Project: 5th Street Commercial
Applicant: 64 and Fifth, LLC, 943 Glenwood Station Lane, Suite 201
Charlottesville, VA 22901
Owner: Morris Creek Yacht Club LLC c/o the Olympia Companies
280 Fore St. Portland, ME 04101
Primary Contact: Katurah Roell, 2811 Hydraulic Road, Charlottesville, VA 22901
Plan received date: 26 Apr 2016
Date of comments: 19 May 2016
Reviewer: John Anderson
Plan Coordinator: Elaine Echols

ZMA201200007

Engineering review

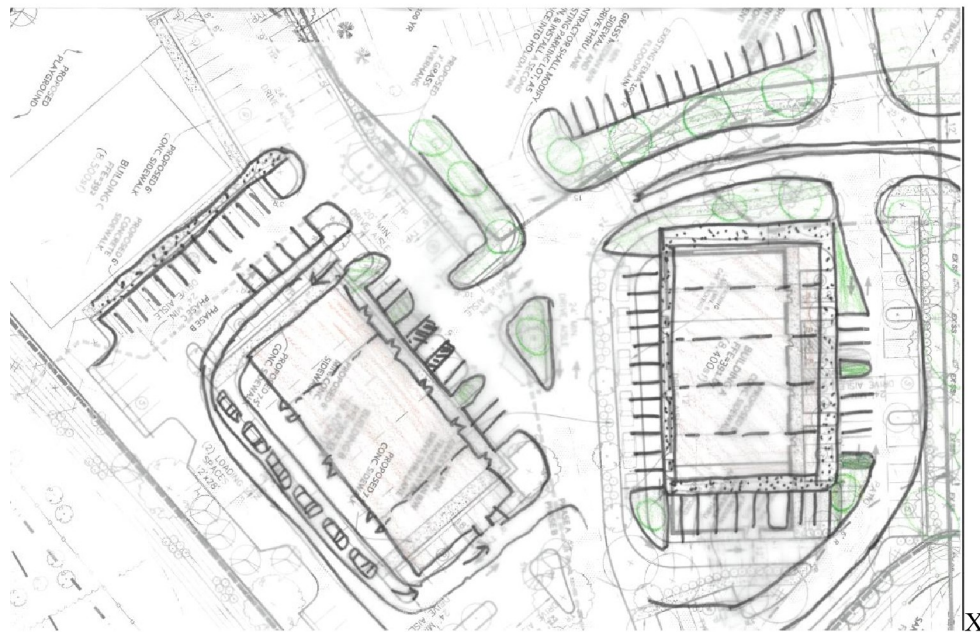
6. Phase A is nearest 5th Street. Building A occupies a prominent location visible from 5th Street, a location preferred by Applicant for a possible high volume franchise. A drive-through is proposed which would require a spiraling, twice-around travel path that introduces additional distance, turning movement, points of vehicle-pedestrian-parking conflict. Alternatives exist. One is switching building A and B. With few modifications, no apparent loss of commercial space (SF), with improved circulation and safety, and enhancing prospects of code preference for 30' Maximum setback while limiting any deviation granted (Applicant has requested Variance (74') to 30' setback /Ref. 18-4.20 and Applicant letter, 18 Apr 2016), Engineering recommends this alternative. Planning provides useful alternative design (image below).

7. Proposed drive-through requires 330'± *additional* travel if compared with alternative building B location, even though building A is closer to 5th St. This distance may modify driver behavior. VDOT required site entrance design for express purpose of increased safety. Patrons, required to circle building A twice, may opt instead to make a U-turn at the end of the median entrance shown on the Application Plan. A U-turn at this location defeats VDOT and county safety objectives. If U-turn at this location is impermissible, the

twice around distance to be traveled by drive-through lane vehicles approaches ¼ mile. Engineering supports alternative design which promotes a direct, shorter travel path to the drive-through lane as limiting number and frequency of pedestrian /vehicle /parking conflicts. Many requirements in recent code revision (18-5.1.60, Drive-Through Windows) relate to safety. Planning's initiative to identify alternative design promotes safe and convenient access to drive-through lane *without* compromise or impact to business revenue. Advertisement (sign) within 5th Street RW will alert passerby to this franchise. This alternative franchise placement (switching buildings A and B) would have all entering site traffic immediately face this building, perhaps increasing revenue. Patrons frequenting the drive-through under the proposed design may believe the building is close, when in fact the drive-through window is at least 330' further away than under the alternative design. Once aware, patron frustration may translate to U-turn movements just past the median-divided entrance. U-turn prohibition is likely to be routinely violated. Alternatives exist. Engineering commends Planning for examining a simple effective design.

17. Circulation Note /Alternative design sketch /tracing courtesy of Planning: Sketched design below meets requirements for *Drive-Through Windows*, 18-5.1.60(a.-j.) with addition of planting strips at least five (5) feet in width separating pedestrian travel ways (walks) and vehicular travel areas (Ref. 18-5.1.60.e.).
